PIC32MZ Embedded Connectivity with Floating Point Unit (EF) Family Silicon Errata and Data Sheet Clarification

The PIC32MZ Embedded Connectivity with Floating Point Unit (EF) family of devices that you have received conform functionally to the current Device Data Sheet (DS60001320), except for the anomalies described in this document.

The following typographic corrections and clarifications are to be noted for the latest version of the device data sheet (DS60001320H):

FIGURE 1: Posc CRYSTAL CIRCUIT

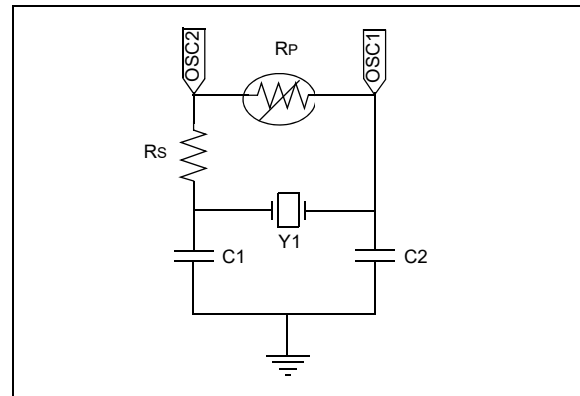
Revision A3 and B3 Silicon: The POSC has been tested in a normal power-up sequence and supports specific crystal operation.

The Primary Oscillator (Posc) has been characterized to operate at 8 MHz, 12 MHz, and 24 MHz when the circuit in [Figure 1](#) is implemented, and the operating conditions listed in [Table 3](#) are met.

Crystal Frequency (see Note 1)	Series Resistor (Rs)	Posc Gain Setting POSCGAIN<1:0> (DEVCFG0<20:19>)	Posc Boost Setting POSCBOOST (DEVCFG0<21>)
8 MHz	2 kΩ	'0b00 (GAIN_0)	'0b1 (ON)
12 MHz	1 kΩ	'0b00 (GAIN_0)	'0b1 (ON)
24 MHz	0 kΩ	'0b00 (GAIN_0)	'0b1 (ON)

- Note 1:** Using any other crystal frequency will require special component selection and characterization.
Note 2: A parallel resistor (Rp) should not be used to increase the gain of the POSC.

64-PIN QFN⁽⁴⁾ AND TQFP (TOP VIEW)

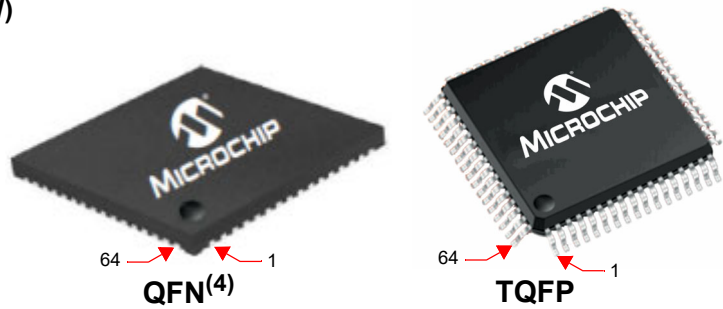
In Table 2. “Pin Names for 64-pin QFN and TQFP Devices” of the current data sheet, the AECRS_{DV} signal was erroneously omitted from the pin number 44 and added to the pin number 62. The correct assignment is shown in bold type in the following table.

Pin #	Full Pin Name	Pin #	Full Pin Name
29	AN9/RPB14/SCK3/PMA1/RB14	61	TRD1/SQID1/ERXD0/PMD1/RE1
30	AN10/EMDC/AEMDC/RPB15/OCFB/PMA0/RB15	62	TRD2/SQID2/ERXDV/ECRSDV/PMD2/RE2
31	OSC1/CLKI/RC12	63	TRD3/SQID3/ERXCLK/EREFCLK/RPE3/PMD3/RE3
32	OSC2/CLKO/RC15	64	AN18/ERXERR/PMD4/RE4
